Re: Minor Project Refinement No. 6 for the South Orange County Reliability Enhancement Project.

# South Orange County Reliability Enhancement Project CPUC Minor Project Refinement Form

### ATTACHMENT B MPR-6 Figure

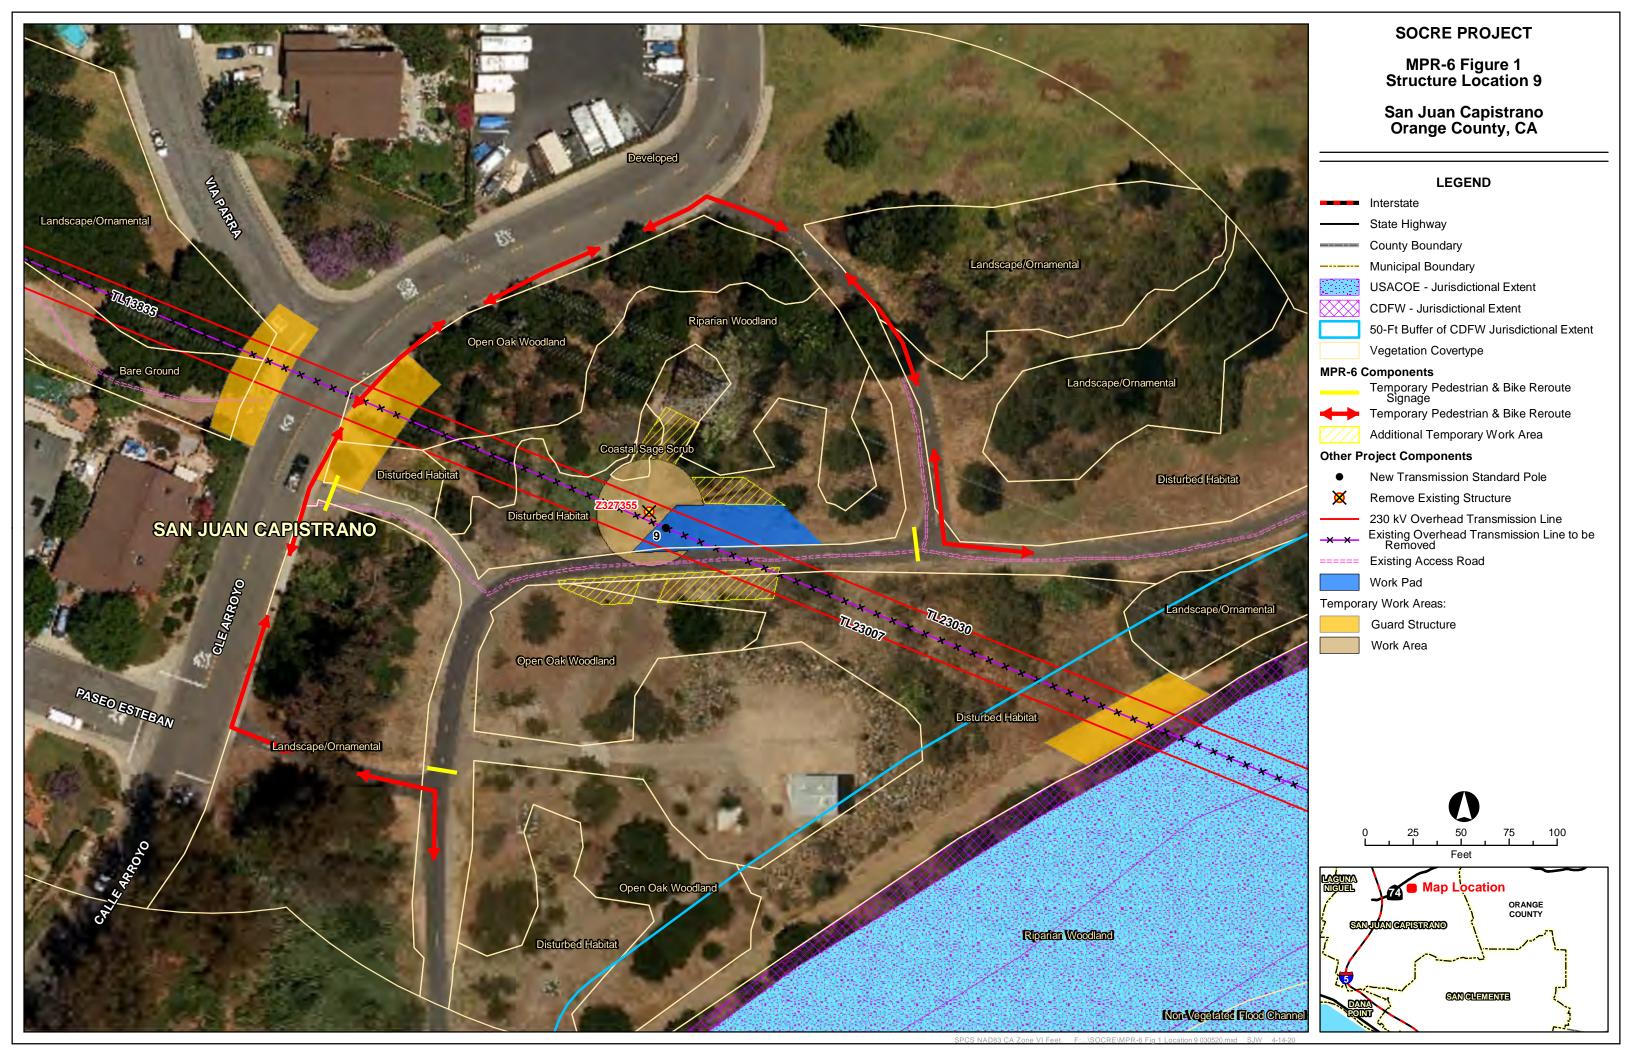
Attachment B, MPR-6 Figure shows the location of the MPR-6 temporary work area.

Justification for Change: Following final design and constructability review in the field, the construction contractor identified the need to gain access to the MPR-6 work area in order to facilitate the construction of Location 09, as there is not enough room within the previously approved work area in NTP-6 to safely and successfully perform the Location 09 pole installation. The FEIR identified a total of 0.15 acre of work area needed at this location which was changed to 0.08 acre in NTP-6. The addition of the 0.05-acre MPR-6 temporary work area will bring the total work area for Location 9 and Z327355 to 0.13 acre. The additional MPR-6 work area will be used for temporary laydown of materials and equipment and will provide additional space to be used for drilling and crane operations associated with Location 09

construction. The portion of the temporary work area south of the access road will also allow adequate space for equipment to safely maneuver and park during Location 09 installation activities (See **Attachment B, MPR-6 Figure**). There will be no trees removed within the MPR-6 work area, however vegetation will be cleared within the work area as necessary using hand tools. No additional access to the MPR-6 work area will need to be constructed.

COA-1. The extent of the MPR-6 additional work area will be limited to the area shown on the figure titled "SOCRE PROJECT, MPR-6 Figure 1, Structure Location 9", and will be used only for additional temporary work area adjacent to the existing approved work area to facilitate construction for new transmission standard pole #09 (Location 09) and existing pole Z327355 as described above. MPR-6 activities will only occur within the SDG&E right-of-way.
